REDLINE REVISION 1 REMOVE SCHOOL CROSSINGS

MD 169 (MAPLE ROAD) AT MD 170 (CAMP MEADE ROAD)

TRAFFIC SIGNAL PLAN

TS NO. 1608 F DRAWING -- OF - SHEET NO. 1 OF 3

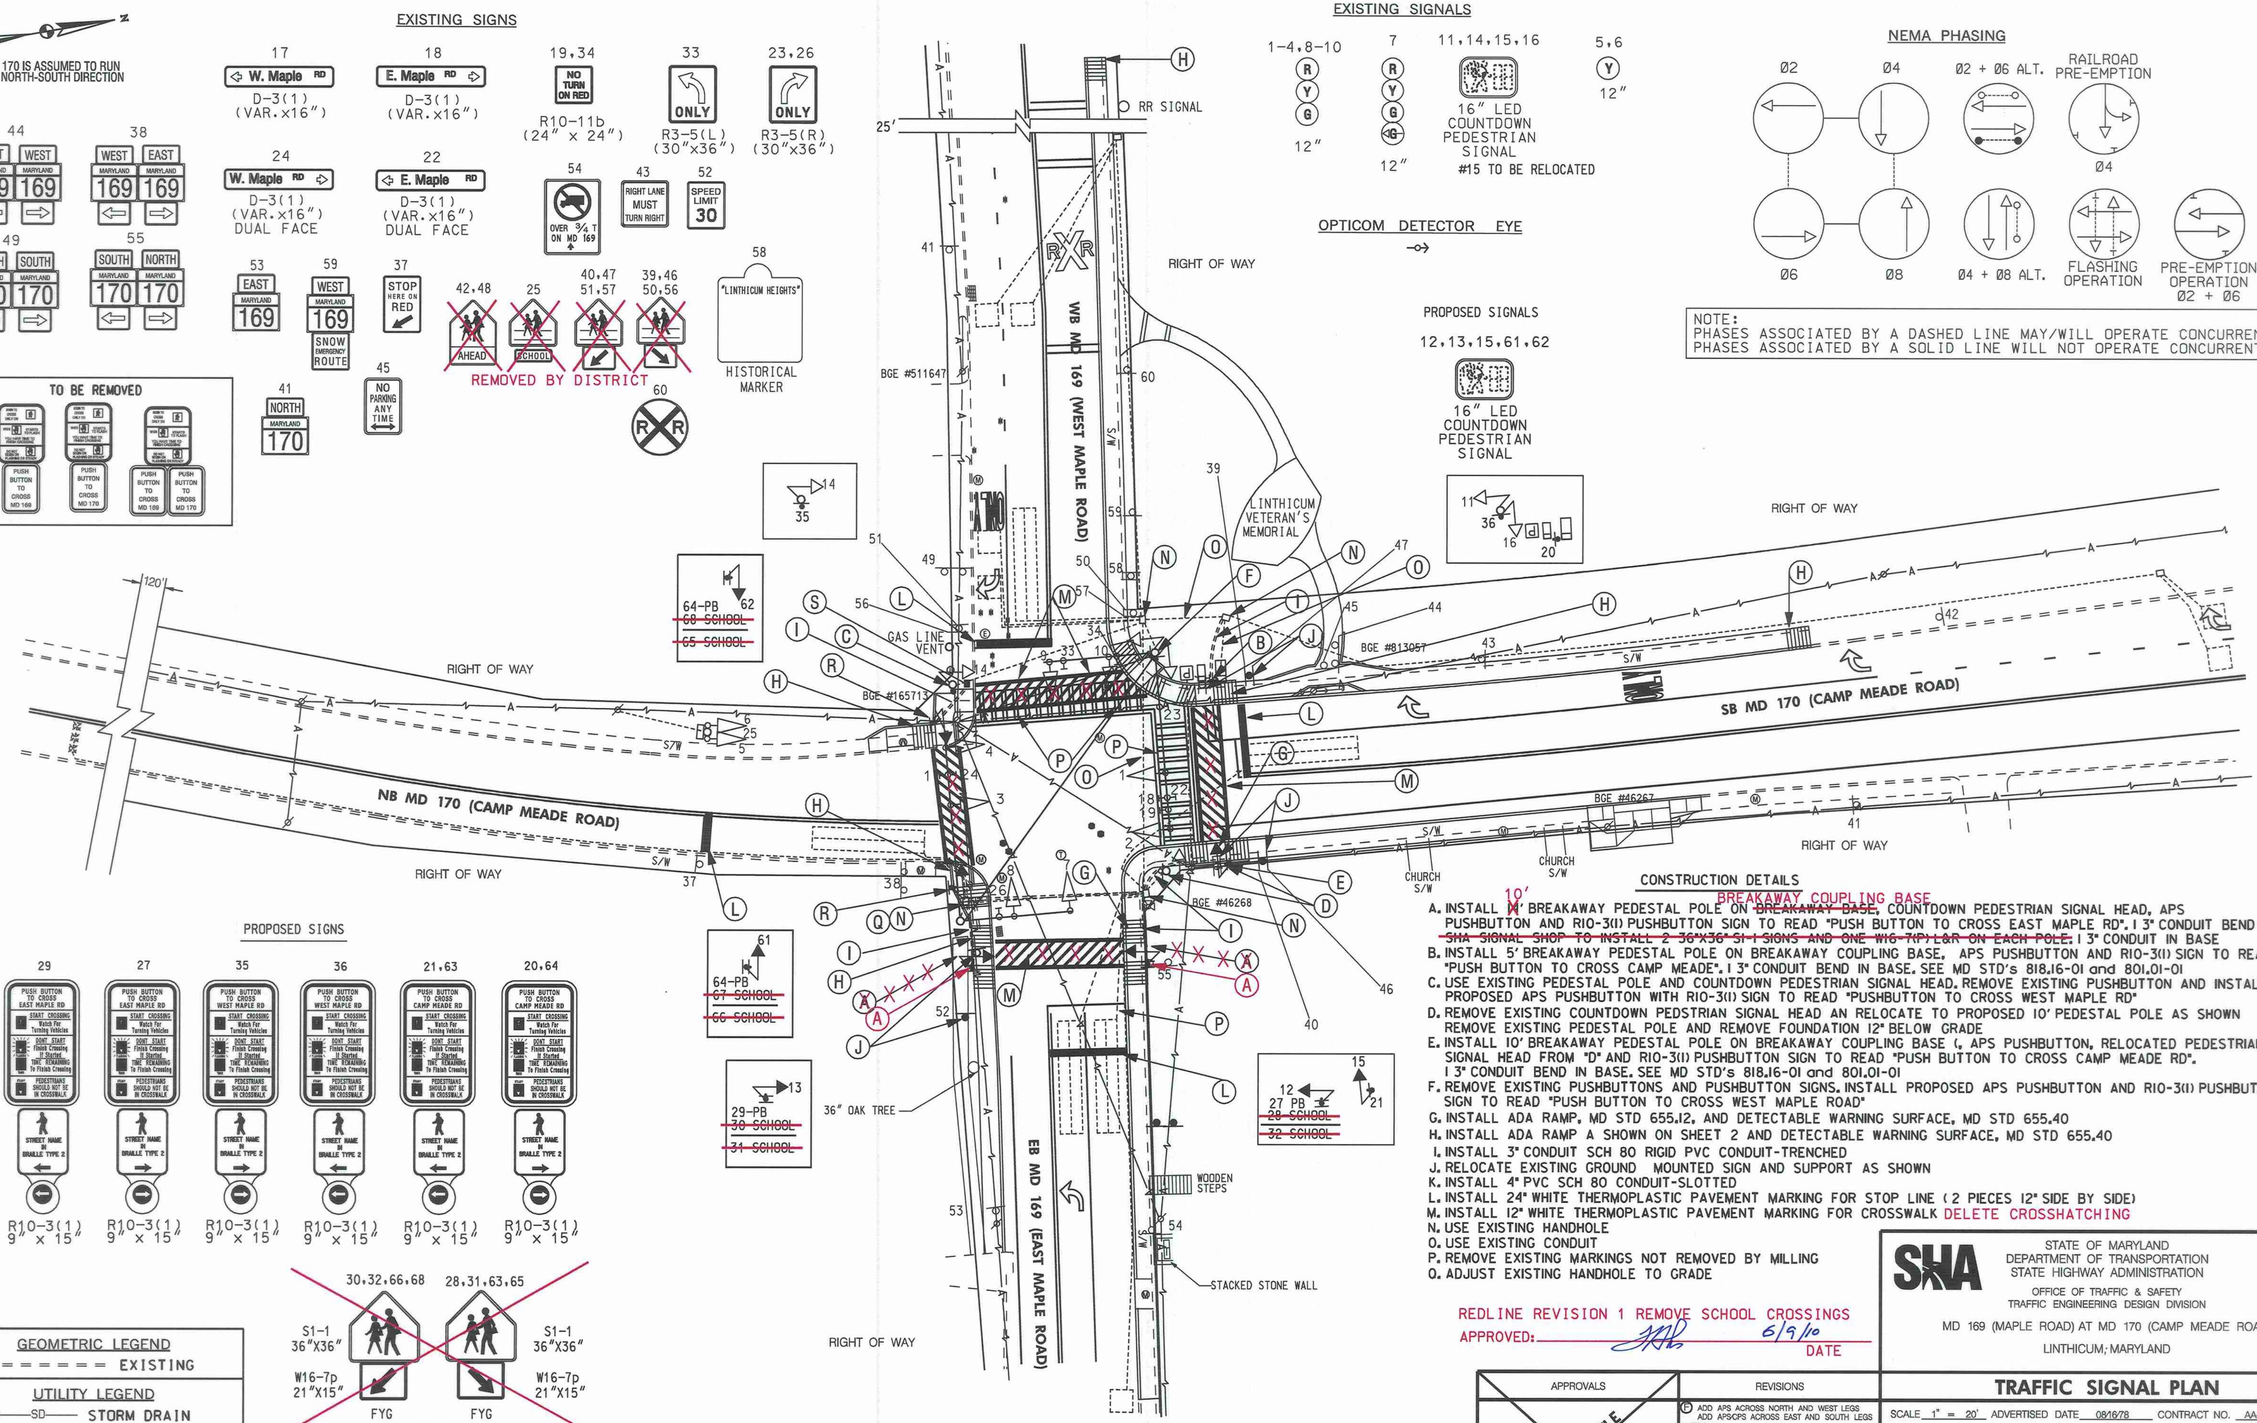
~~30,32,66,68~~ S1-1 36"X36" W16-7p 21"X15" FYG

~~28,31,63,65~~ S1-1 36"X36" W16-7p 21"X15" FYG

A. INSTALL ~~M~~ 10' BREAKAWAY PEDESTAL POLE ON ~~BREAKAWAY BASE~~ BREAKAWAY COUPLING BASE, COUNTDOWN PEDESTRIAN SIGNAL HEAD, APS PUSHBUTTON AND R10-3(I) PUSHBUTTON SIGN TO READ "PUSH BUTTON TO CROSS EAST MAPLE RD". 1 3" CONDUIT BEND IN BASE ~~SHA SIGNAL SHOP TO INSTALL 2 36"X36" S1-1 SIGNS AND ONE W16-7(P) L&R ON EACH POLE.~~ 1 3" CONDUIT IN BASE

R. INSTALL ~~M~~ 10' BREAKAWAY PEDESTAL POLE ON ~~BREAKAWAY BASE~~ BREAKAWAY COUPLING BASE, COUNTDOWN PEDESTRIAN SIGNAL HEAD, APS PUSHBUTTON AND R10-3(I) PUSHBUTTON SIGN TO READ "PUSH BUTTON TO CROSS CAMP MEADE RD". 1 3" CONDUIT BEND IN BASE ~~SHA SIGNAL SHOP TO INSTALL 2 36"X36" S1-1 SIGNS AND ONE W16-7(P) L&R ON EACH POLE.~~ 1 3" CONDUIT IN BASE
